Product Change Notification - KSRA-22BGIU893

CCB 4038 Initial Notice: Qualification of MPHL as a new final test site for selected Atmel ATTINY16x7, ATTINY8x7, ATTINY417 and ATTINY3217 device families available in 24L QFN (4x4x0.9mm) packages.

CCB 4038_ Pre and Post Change Summary
PCN# KSRA-22BGIU893

QUALIFICATION PLAN SUMMARY

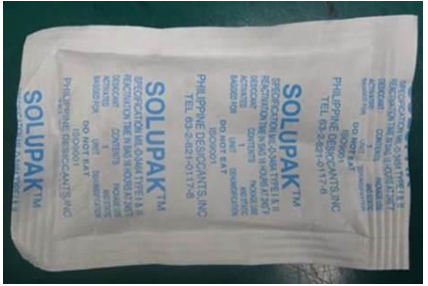
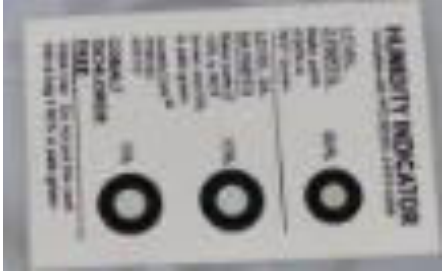
Pre and Post Change - REEL

| | Post Change | | | | | Pre Change | | | | |
| Carrier Tape | Width | Pitch | A0 | B0 | K0 | Width | Pitch | A0 | B0 | K0 |
| | 12.0 ±0.3 mm | 8.00 ±0.1 mm | 4.30 ±0.1 mm | 4.30 ±0.1 mm | 1.10±0.1 mm | 12.0 ±0.3 mm | 8.00 ±0.1 mm | 4.35 ±0.1 mm | 4.35 ±0.1 mm | 1.10±0.1 mm |
| Cover Tape | Width | Thickness | Adhesive width | Part No. | Method | Width | Thickness | Adhesive width | Part No. | Method |
| | 9.3 ±0.1 mm | 0.06 ±0.006 mm | 1.0 ±0.15 mm | CP63 | Heat Pressure | 9.3 ±0.1 mm | 0.05 ±0.005 mm | 1.0 ±0.15 mm | CP58 | Pressure |
